Product Change Notification / SYST-18WWYC201

Data Sheet - KSZ8081RNA/RND - 10Base-T/100Base-TX PHY with RMII Support Revision

Description of Change: Revision includes:

FIGURE 1-1: SYSTEM BLOCK DIAGRAM

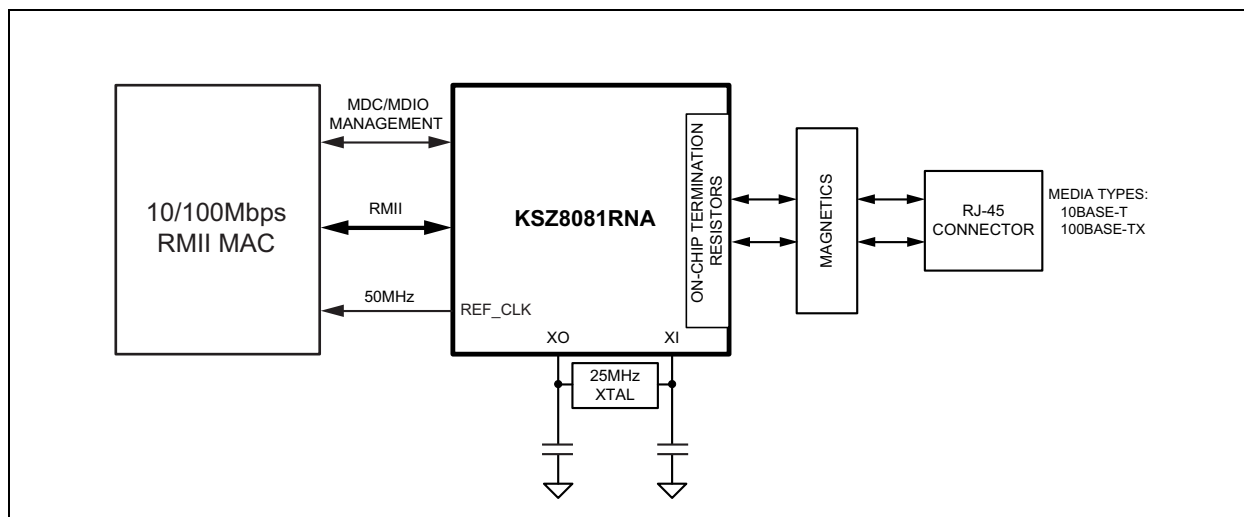
1. Figure 1-1: Updated figure to remove capacitor values.
2. Table 2-1: Updated description of Pins 8 and 16 to indicate RND crystal limitation.
3. Section 3.0: Updated 5th paragraph for clarity
4. Section 3.2.2.1: Updated bullet pointed text to indicate RND crystal limitation.
5. Figure 3-2: Updated figure to remove RND label and capacitor values.
6. Table 4-2: Added Bit 18.6 and added note to Bit 1F.7 for RND crystal limitation.
7. Section 10.0: Updated introductory text for RND crystal limitation.
8. Figure 10-1: Updated figure to remove capacitor values.
9. Section 11.0: Minor edits to introductory text for clarity.

DS00002199E (07-02-21)	Global	Updated data sheet metadata to reflect the correct contents of this document.
DS00002199F (10-18-21)	Figure 1-1	Updated figure to remove capacitor values.
	Table 2-1	Updated description of Pins 8 and 16 to indicate RND crystal limitation.
	Section 3.0	Updated 5th paragraph for clarity.
	Section 3.2.2.1	Updated bullet pointed text to indicate RND crystal limitation.
	Figure 3-2	Updated figure to remove RND label and capacitor values.
	Table 4-2	Added Bit 18.6 and added note to Bit 1F.7 for RND crystal limitation.
	Section 10.0	Updated introductory text for RND crystal limitation.
	Figure 10-1	Updated figure to remove capacitor values.
	Section 11.0	Minor edits to introductory text for clarity.
